211988Orig1s000

**ADMINISTRATIVE and CORRESPONDENCE
DOCUMENTS**

MEETING MINUTES

Application Number: IND 125927
Product Name: HTX-011 (bupivacaine and meloxicam extended-release solution)

Figure 4: Updated Briefing Document Figure 9: Bupivacaine C_{max} Versus AUC_{inf} Following a Single Injection of Bupivacaine HCl in Various Surgical Models (includes additional cohorts from Phase2b Studies 209 and 211)

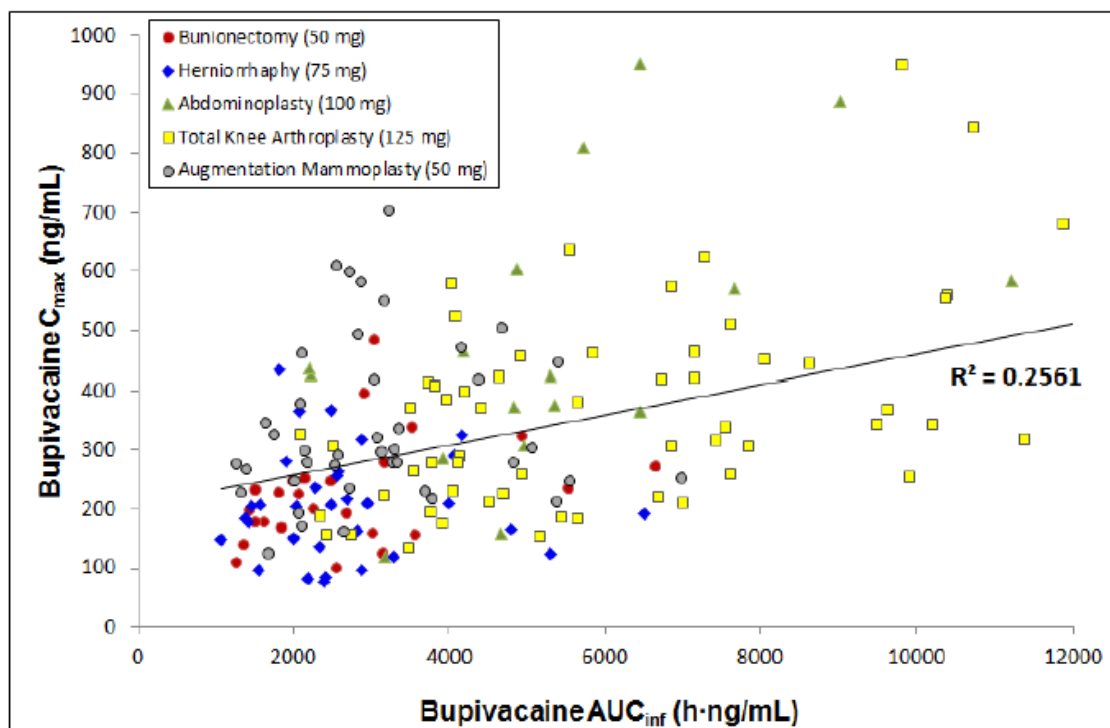
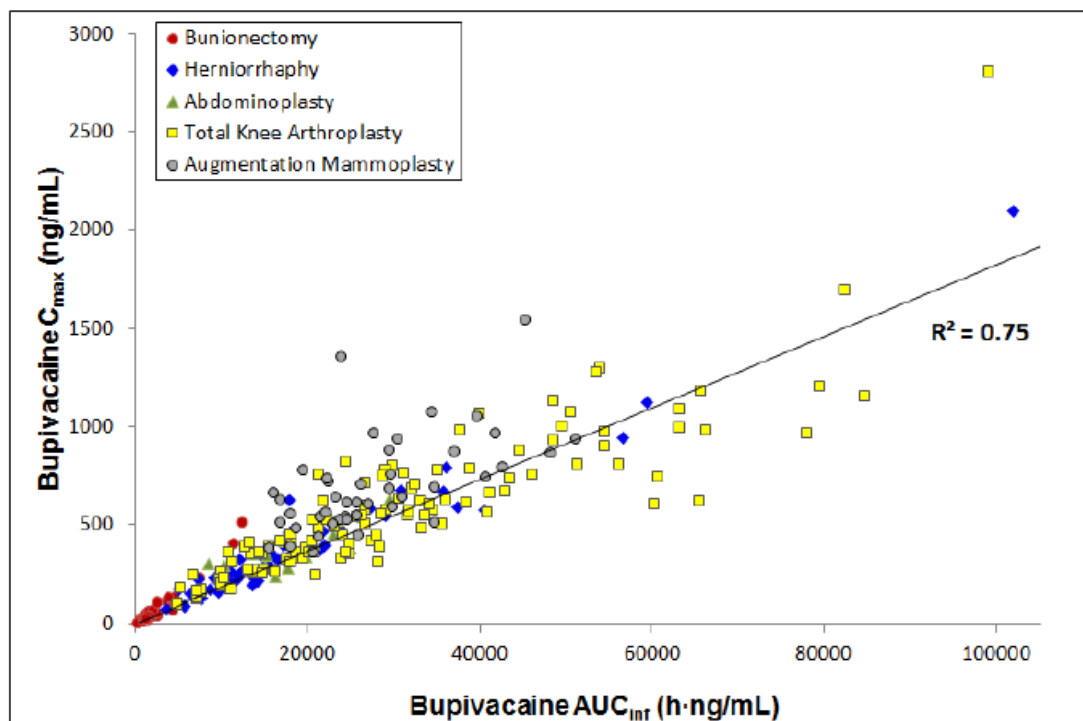
In addition, when we assessed the dose-proportionality among different doses of HTX-011, in different surgical procedures using the mean AUC_{inf} and C_{max} values provided in the meeting package, we note that HTX-011 does not exhibit dose-proportionality for bupivacaine or meloxicam. See our response to Question 12.

The size of the surgical incision and vascularity can only have an effect on the rate of absorption; dose is an independent variable and clearance will be unaffected. Therefore, to isolate the effect of surgical size and vascularity, the rate of absorption from the site of administration must be understood. One way this can be accomplished is by evaluating the relationship between $C_{\max}$ and AUC. In a plot of $C_{\max}$ vs AUC, the effects of dose and clearance rate are cancelled out and we are left only with the rate of absorption that is proportional to the slope of the line formed by the data points. If the rate of absorption is consistent, then the data points for all subjects will form a single line indicating they all have the same rate of absorption. The greater the scatter (ie, the more the data points deviate from the regression line), the greater the variability in absorption. As can be seen in the plot of $C_{\max}$ vs AUC for bupivacaine HCl (Figure 4), there is a large scatter in the data points around the line of regression indicating high variability in the rate of absorption of bupivacaine HCl. This is consistent with historical clinical experience. In contrast, there is much less scatter about the regression line for the same plot with HTX-011 (Figure 5). For example, the results from bunionectomy, with a small dose in a small surgical site, fall on the same regression line as the results for TKA and herniorrhaphy, which have much higher doses, larger surgical sites and higher vascularity. This indicates that the rate of absorption of bupivacaine from HTX-011 is relatively independent of surgical size and vascularity. Absorption of bupivacaine into the surrounding tissues, once released from bupivacaine HCl, is very rapid compared to the rate of release of bupivacaine from HTX-011; thus, the rate of release of bupivacaine from HTX-011 is the rate-controlling step in systemic absorption.

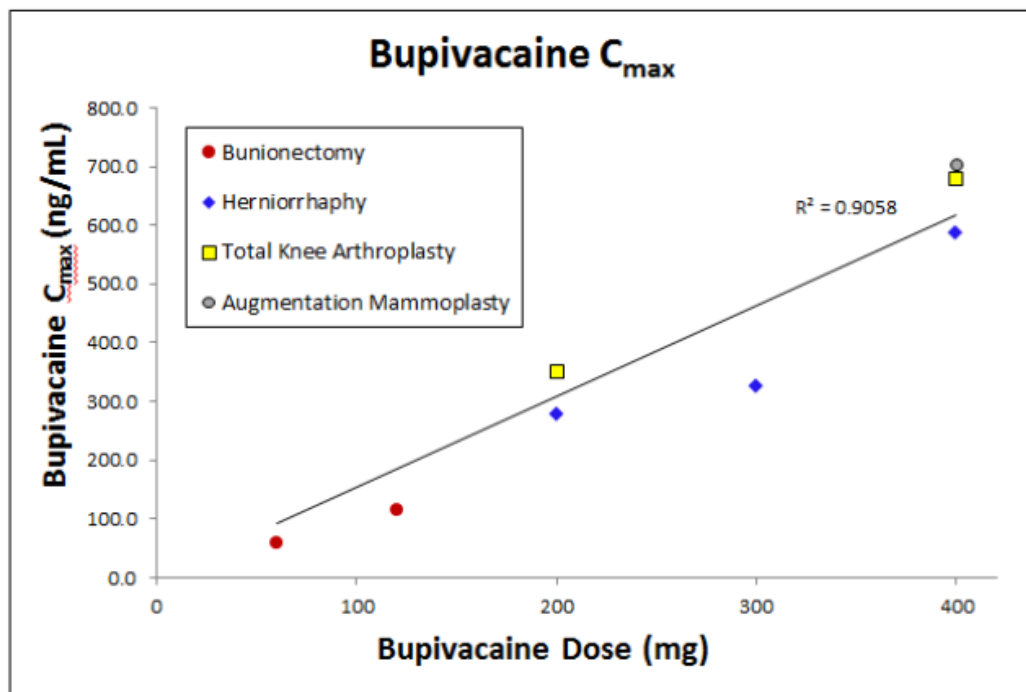
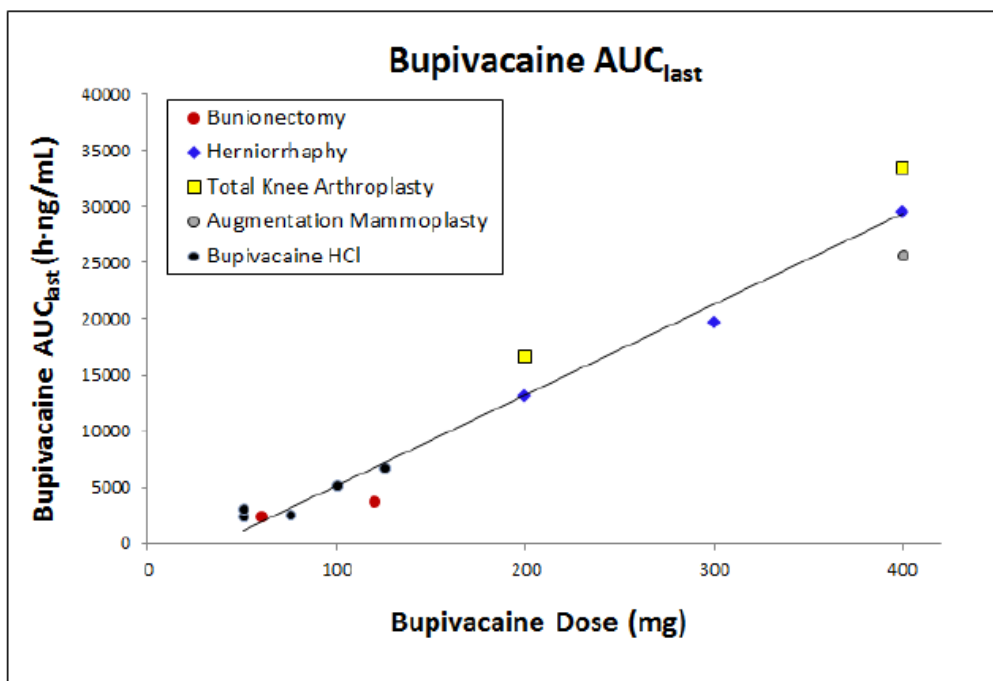
the Sponsor to submit PK graphs with different dosages and procedures on the same graph to show how the PK profiles are different. The Division informed the Sponsor to plot individual data to show variability as well as mean data. The Sponsor agreed and will look at release rate at the site over time as well as variability over surgical procedures.

For a parenterally-administered product, one expects that there is 100% bioavailability. Therefore, AUC should be linear with dose if there is a sufficient sample size. This is the case with both HTX-011 and bupivacaine HCl; we in fact see that AUC is quite linear over a very wide range of doses even when including both bupivacaine HCl and HTX-011. The higher AUC values for HTX-011 simply reflect the higher overall mass of bupivacaine administered over the 3-day period.

Figure 1 Mean (SE) NRS-A Pain Intensity Scores in Studies 301 and 302 Using wWOCF (ITT Population)

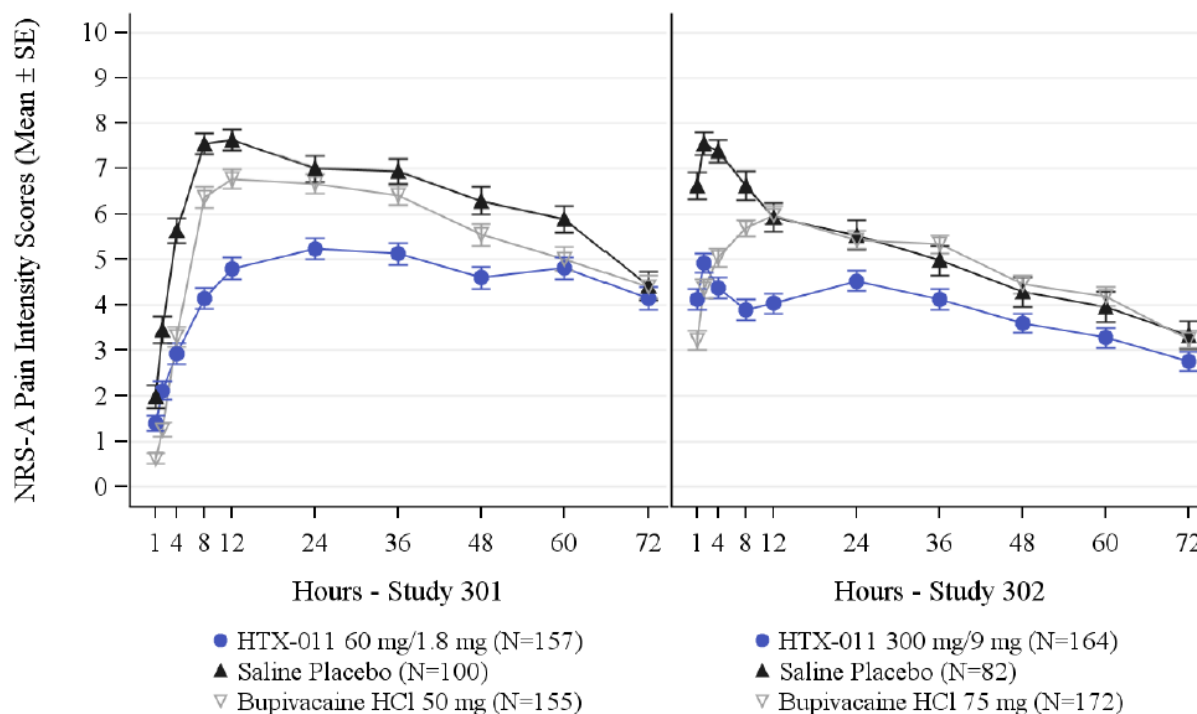
Both plots in Figure 1 demonstrate separation of the pain curves for the initial 60 hours. However, in both studies, the differences in pain scores become much less pronounced around 60 hours. In Study 301, at 60 hours, the bupivacaine HCl and the HTX-011 confidence intervals appear to overlap, and

by 72 hours all three groups converge. In addition, separation between the placebo and the bupivacaine HCl groups is apparent in the first 12 hours. In Study 302, the confidence intervals in the HTX-011 and bupivacaine HCl group approach each other at 60 hours, and appear to overlap by 72 hours. Similarly to Study 301, the bupivacaine HCl and placebo group curves demonstrate distinct separation for the first 12 hours, as expected, and converge thereafter. In summary, Figure 1 demonstrates that although there is a statically significant difference in the mean AUC₀₋₇₂ of HTX-011 group controlled to the control groups in both studies, the statistically significant differences are clearly present in the first 48 hours, with smaller differences noted in the 48-72 hour period. The p-values for each appropriate time period is presented in Table 3:

Figure 5 Mean Pain Intensity Scores at Each Assessed Timepoint Through 72 Hours For HTX-011 and EXPAREL vs. Saline Placebo Following Bunionectomy

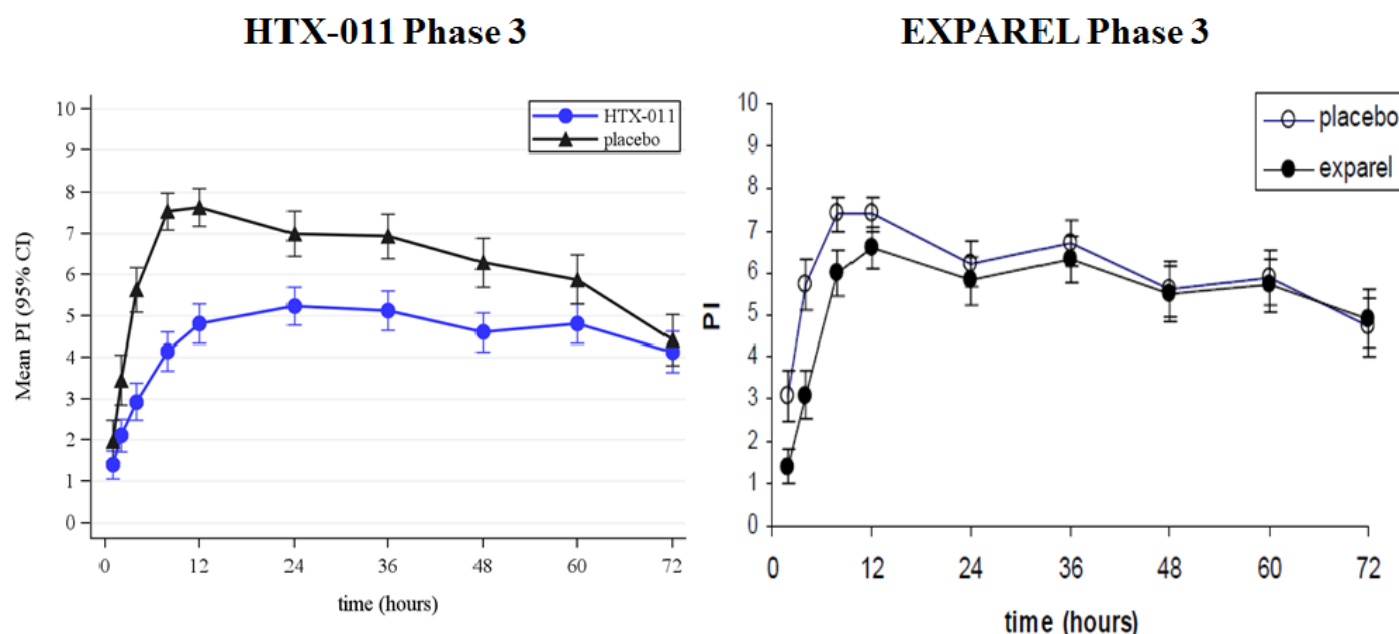
(37%, 31%, and 27%, respectively) compared with Exparel (16%, 10%, and 7%). However, it is important to consider the differences in the pain assessments in these studies (HTX-011 study utilized NRS-A (with activity) score, whereas the Exparel study utilized the NRS-R (with rest) score). The inherent difference in pain with activity versus pain at rest makes the presented comparison more difficult to interpret.

Another observation presented by the Applicant pertains to the peak pain intensity score differences between HTX-011 and Exparel, in each respective study. The mean NRS-A pain intensity scores in the HTX-011 group peaked at approximately the numerical value of “5,” and remained below the pain intensity values for placebo until 72 hours, with significant differences noted for the 24 to 48-hour and 48 to 72-hour time periods (Figure 1). In contrast, the mean NRS-R pain intensity scores for Exparel peaked at approximately the “7.5” numerical value, 25% higher than HTX-011. In addition, although the NRS-R scores for Exparel were lower than those for placebo for approximately 24 hours after study drug administration, there was no difference beyond 24 hours evident by the overlapping confidence intervals from 24 to 72 hours.
